F/YR23/0541/F

Land North of The Barn High Road Bunkers Hill Cambridgeshire

Erect 5 x dwellings (2-storey 5-bed) involving the formation of a new access

Officer recommendation: REFUSAL

Drawing number
1405-0700-001

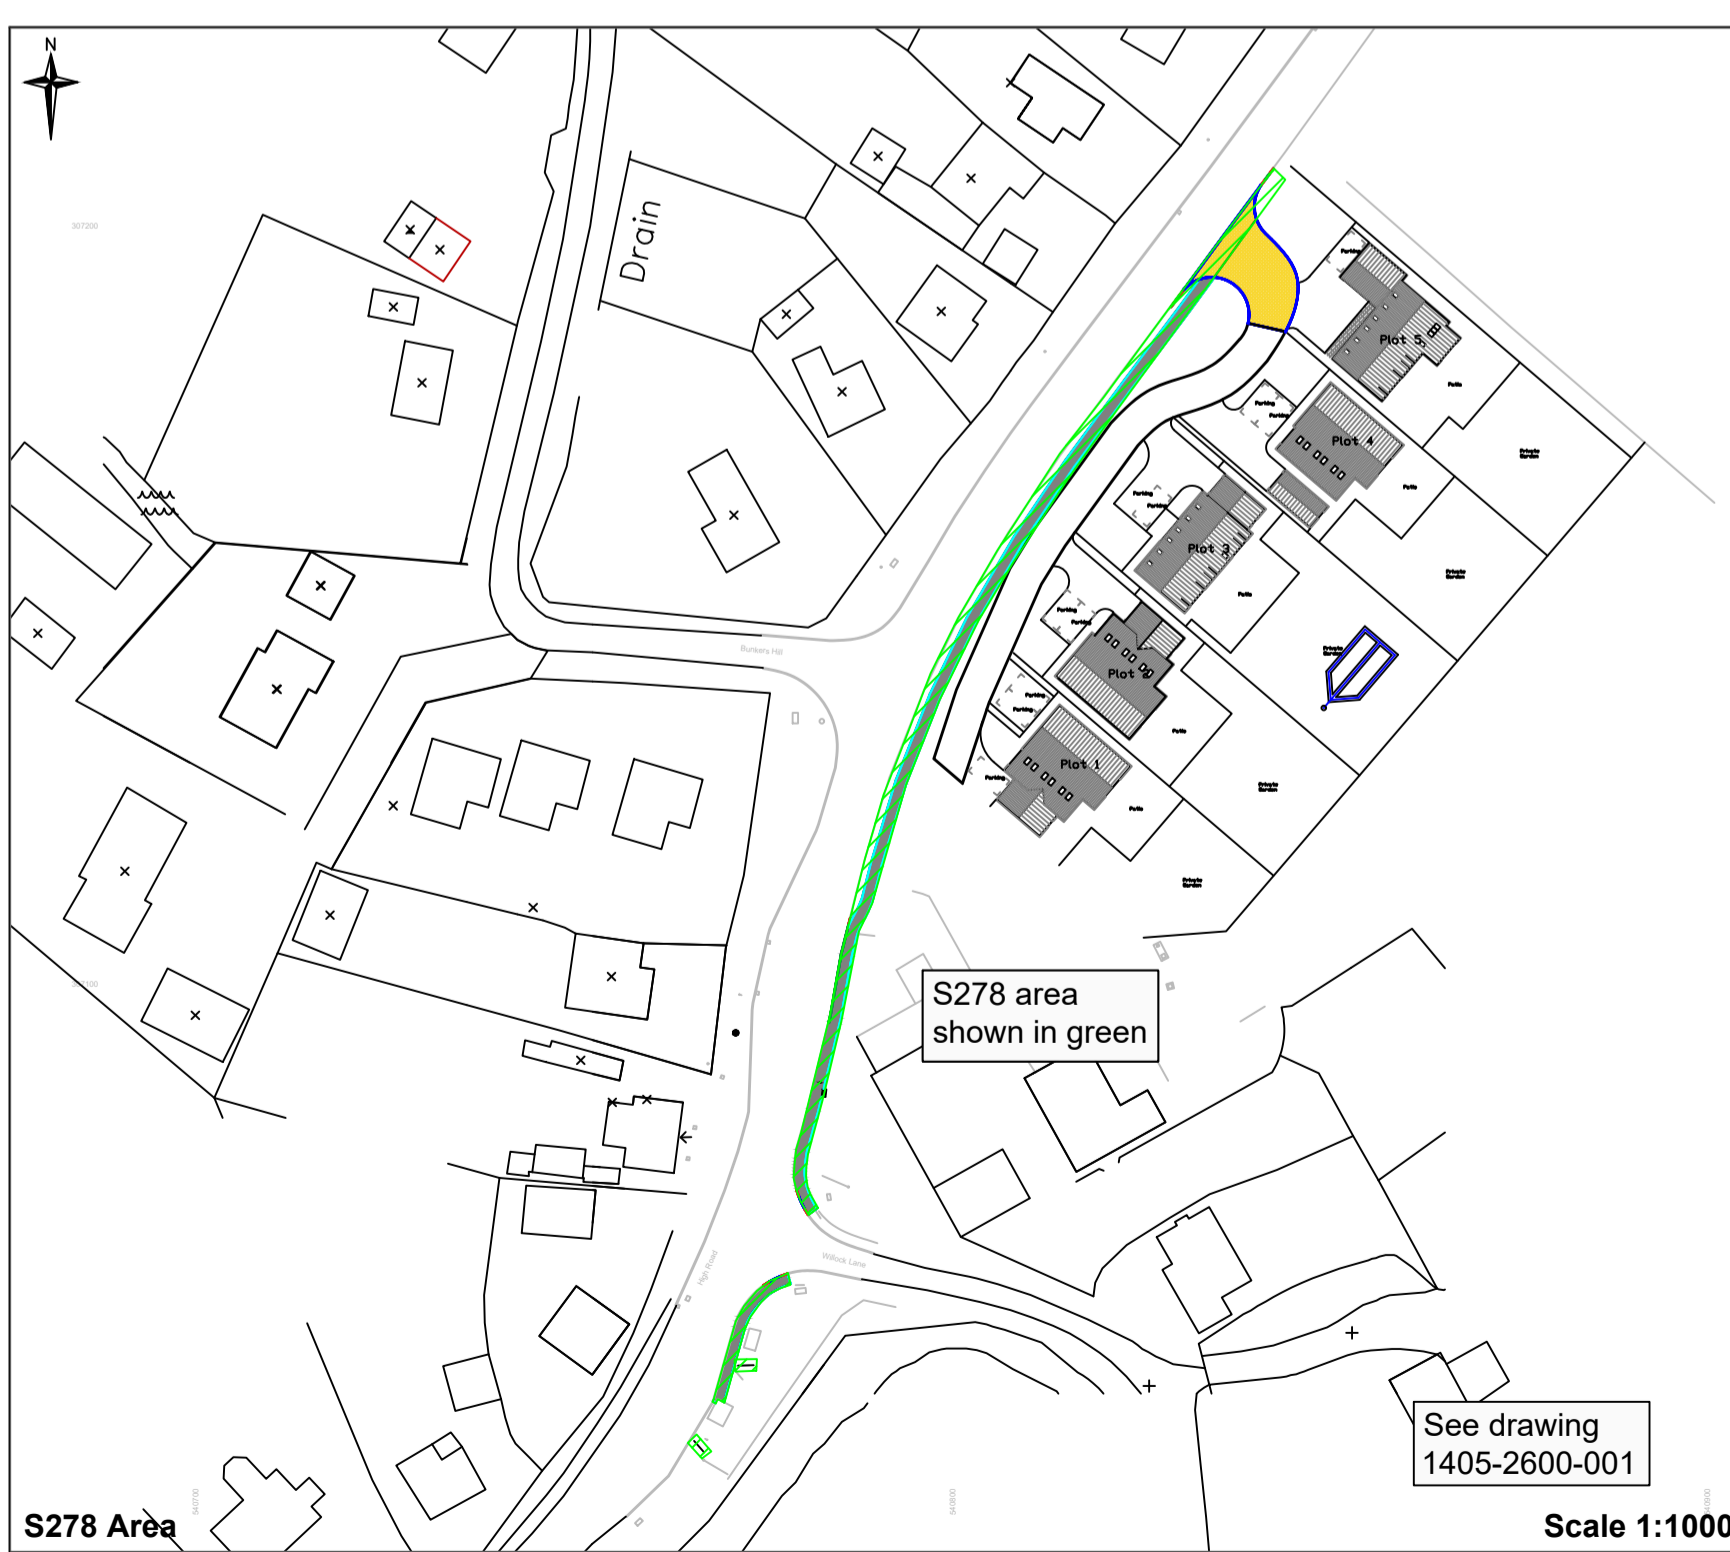
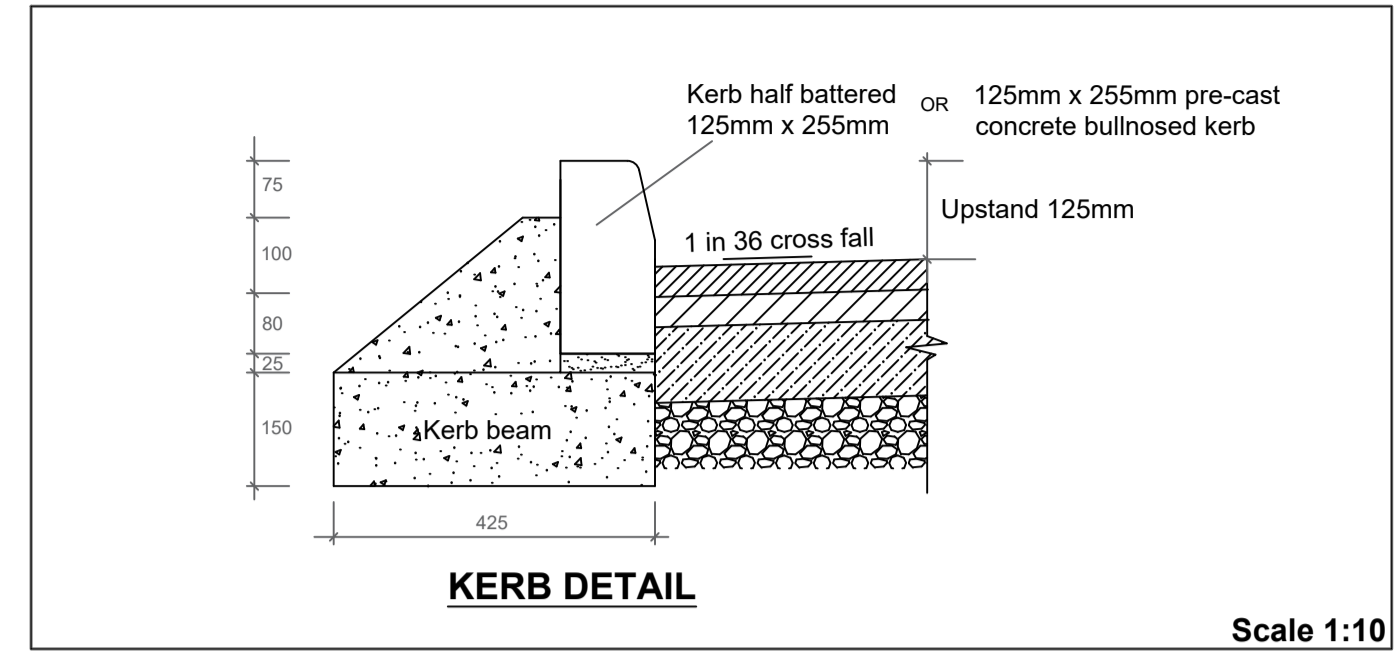
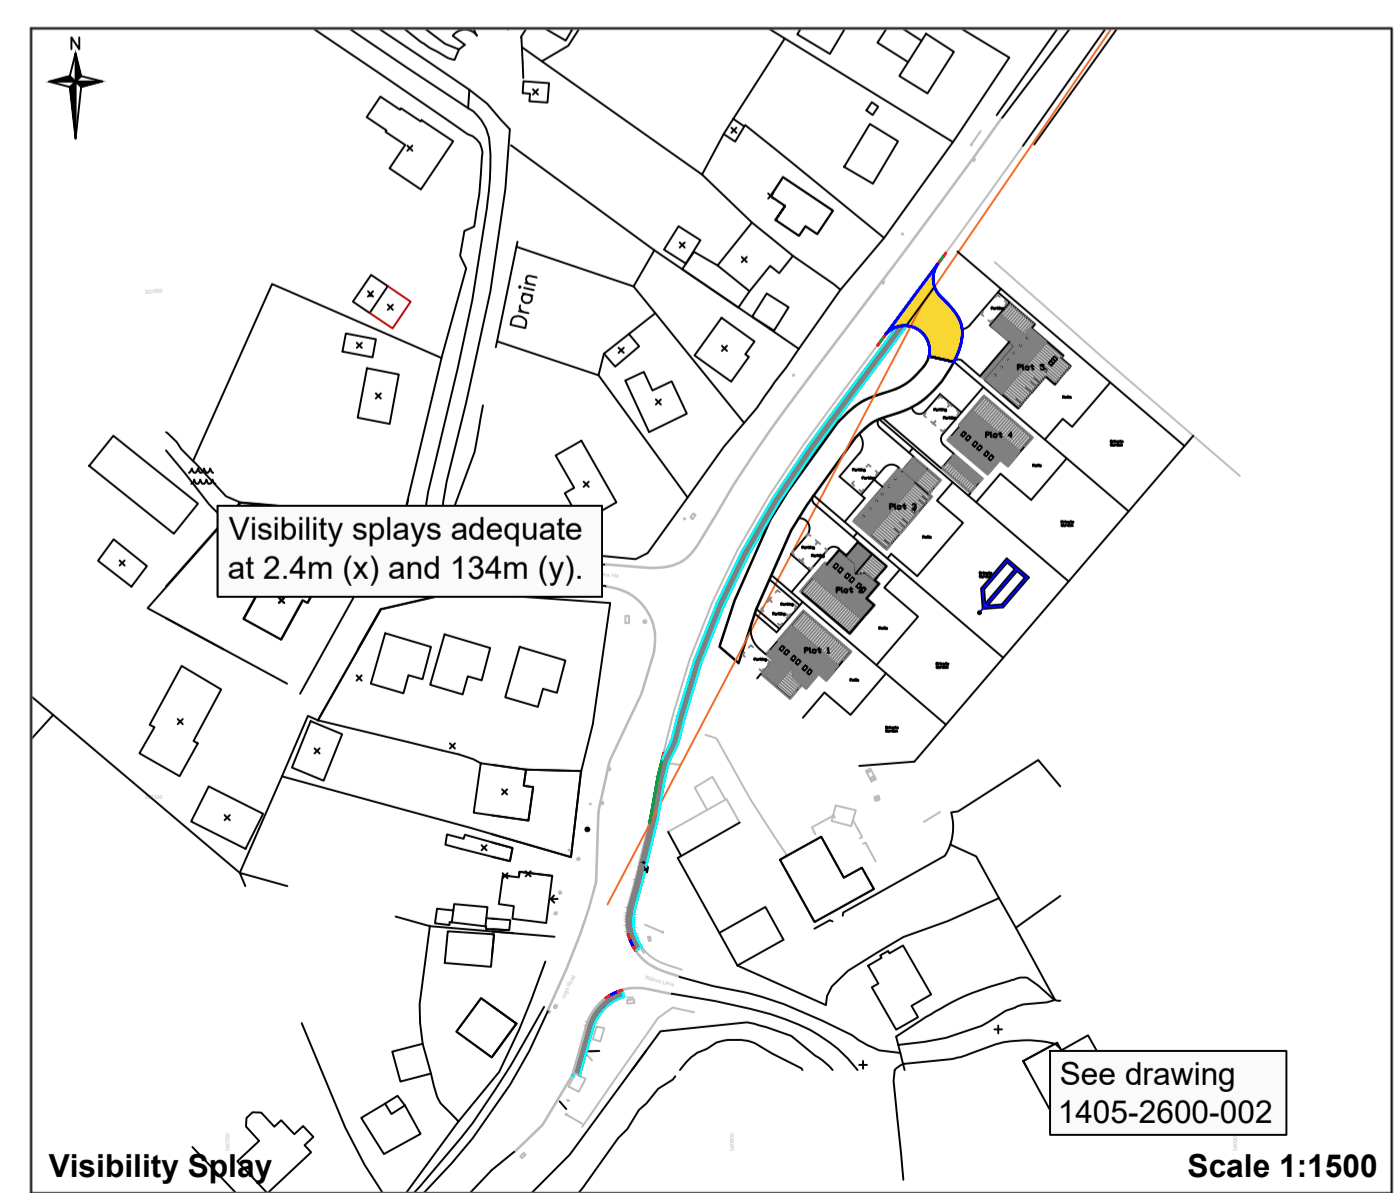
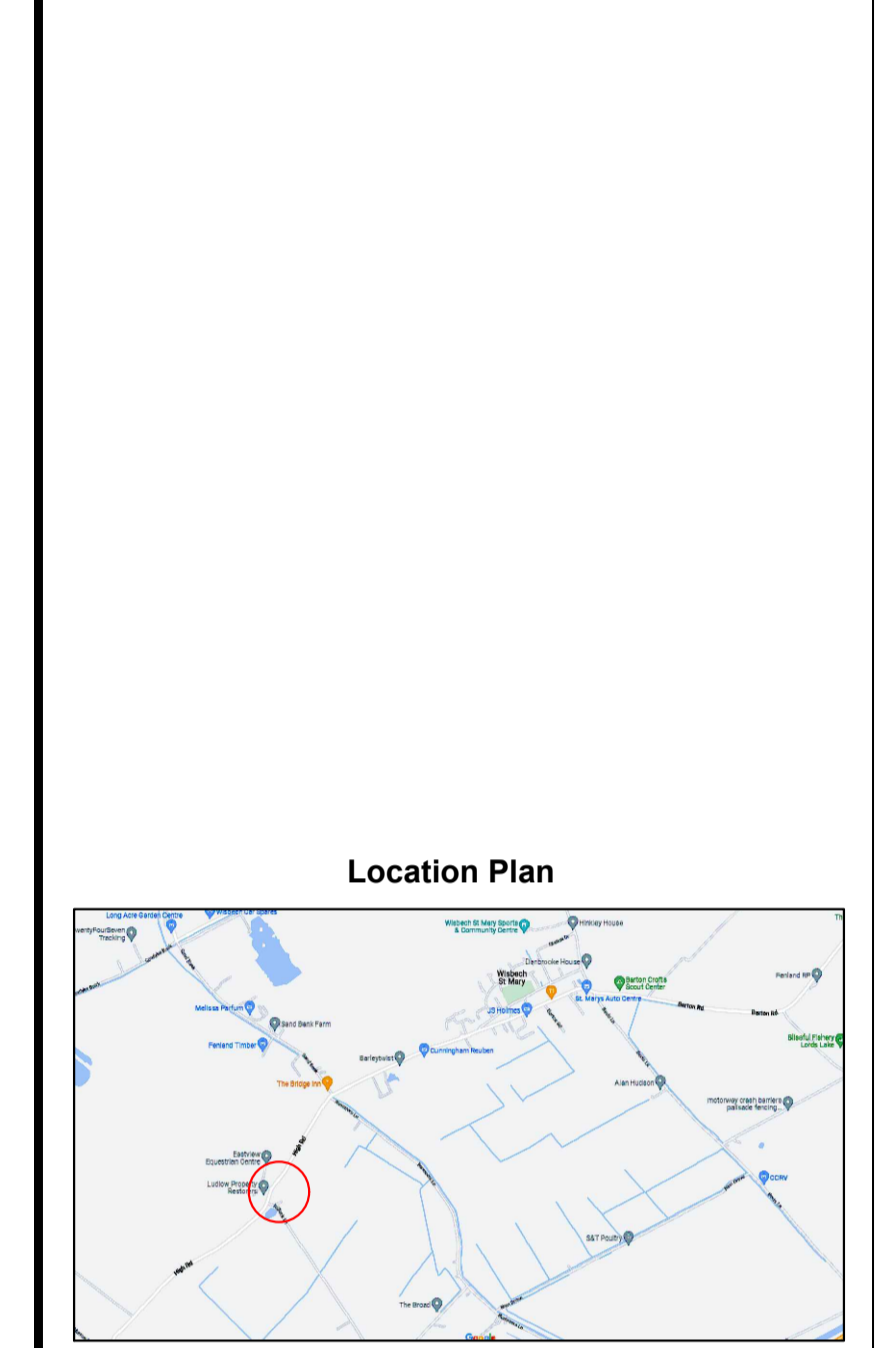
I note that this development is to utilise the position of an access previously permitted with respect to F/YR20/0598/O. While I have no objections in this regard, the applicant would need to demonstrate that the visibility splays previously approved can be achieved within public Highway or land within the applicant's control, noting that the red line boundary on this plan differs from that on the previous application. I would also note that the visibility splay shown on drawing 1405-260-002 is incorrectly detailed and should be measured to the point at which it crosses the near side channel line of the road. The splay previously provided is below that normally required for a derestricted road. This was based upon submission of supportive speed data, which should be similarly provided as part of this separate application.

I note that the previous outline application required a 1.8m footway rather than the 1.5m shown. The current standard for footway requires a 2m wide surface, and while a narrower footway may be acceptable where physical restrictions prevent anything wider, the initial design must first look to provide widths to current standards. The applicant should be invited to amend plans accordingly. The proposed footway is shown offset by 0.9 m from the carriageway edge, presumably to allow overedge drainage from the carriageway and avoid the need of kerbing that may require installation of a positive drainage system. While I am not averse to this solution in principle, it is unclear whether the remaining verge would be sufficient to permit the necessary percolation, especially given the additional impermeable area created by the new footway.

The footway as shown appears to be located on the embankment/change in level and it is unclear how the applicant is proposing to adjust levels to accommodate construction, or what effect this will have on adjacent land. This is of particular concern were located adjacent to land not in the applicant's control and that section close to the proposed private driveway where there is a risk of a step being created.

This issue may affect feasibility of construction and the applicant should therefore be invited to provide clarification in this regard, including cross section describing how levels will be adjusted and highlighting the relative position of highway, the extent of land in their control and the effect on any third party land.

A shared private drive serving five dwellings should be served off a simple verge crossing rather than a kerbed junction. While this could be relaxed in this case given the location of the site, the detail provided on GA2 combines features of both crossing and junction on one plan. This should be rationalised to either remove the dropped kerb on the kerb line or the junction radii. Where radii are provided, these should be dimensioned and comply with the Highway Authorities requirements for s278 works. No details have been provided to indicate how private surfaces will be drained independently of the public highway.
